# Alternatives to Energize Eastside

## Response to Draft EIS

*February 15, 2016*

Prepared for:  
CENSE

Figure 1: DER potential at PSE above the DSR 100% forecast

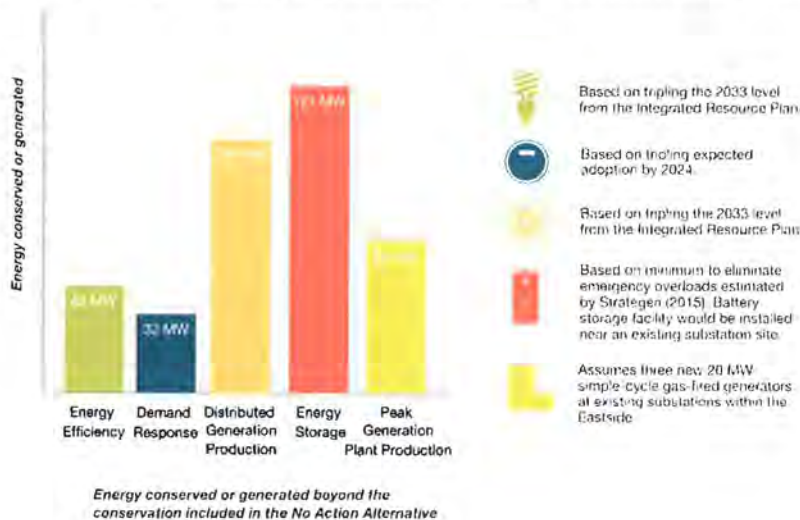
A proper analysis would include accurate peak load forecast, cost effectiveness analysis, and ideally an all source RFI. A rule of thumb Eastside forecast is provided in Figure 1 below.

To put it simply, Alternative 2 DER would avoid ratepayer funding for transmission, distribution, generation, and environmental costs. To meet the peak load growth Puget Sound Energy will request to spend over \$300MM on Energize Eastside and another \$300MM for a peaking power plant (PSE 2015 IRP). If we assume that expected peak load to be met is 200 MW, the capital expenditure would be \$3,000/kW. Most DER, TODAY, can be installed and operated for less. When you consider expected cost reductions and performance improvements Alternative 2 is the lowest cost choice.<sup>2</sup>

Figure 3: PSE 2015 IRP Figure 5-21: Electric Peak Demand Forecast before DSR 2015 IRP Base Scenario versus 2013 IRP Base Scenario Hourly Annual Peak (23 Degrees, MW)

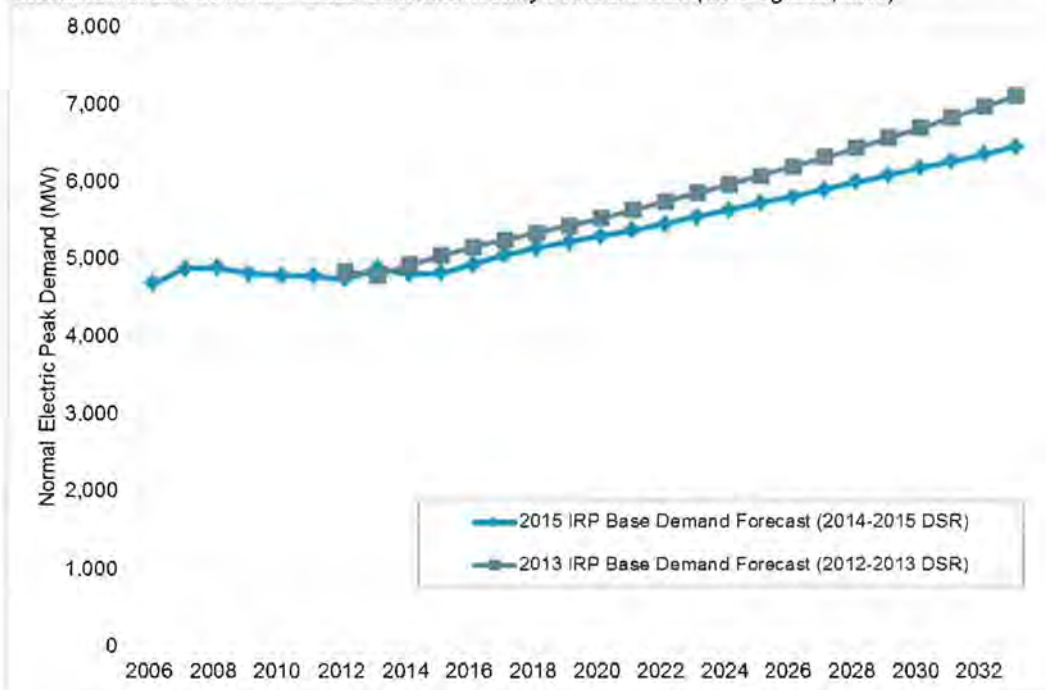
Figure 2 below shows how peak load is historically flat, then suddenly takes off in the future. You'll find this to be true with PSE's previous peak load forecasts. I understand that forecasts are, by their nature are wrong, but PSE has a habit of overestimating peak load.

Winter peaks have gone down in the Pacific Northwest in the last 5 years, and growth in the winter peak will continue to be less than the increase in growth in energy use. PSE's winter peak decreased by 11 MW from 2013 to 2014. This holds true because:

PSE's 2011 IRP had peak forecasts rising from 2011 forward.<sup>3</sup> This is not happening.

Figure 5-27: Electric Peak Forecasts by County (MW), after applying 2013 IRP DSR

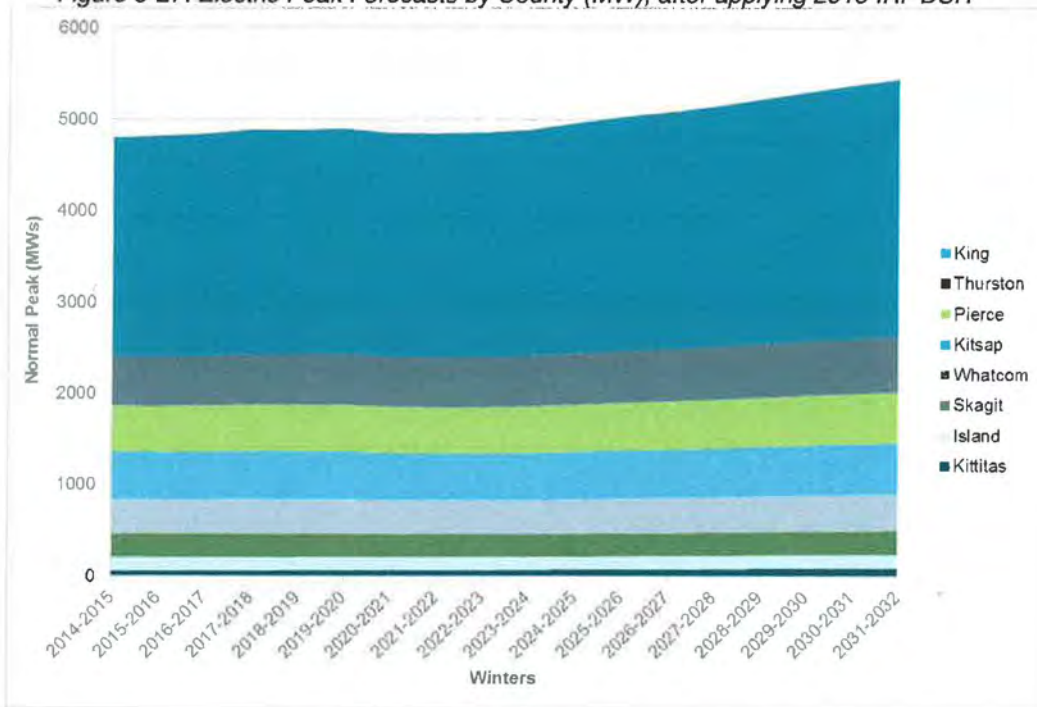
**Notice in Figure 5-27 from PSE's 2015 IRP, the peak demand does not begin to increase until 2024.**
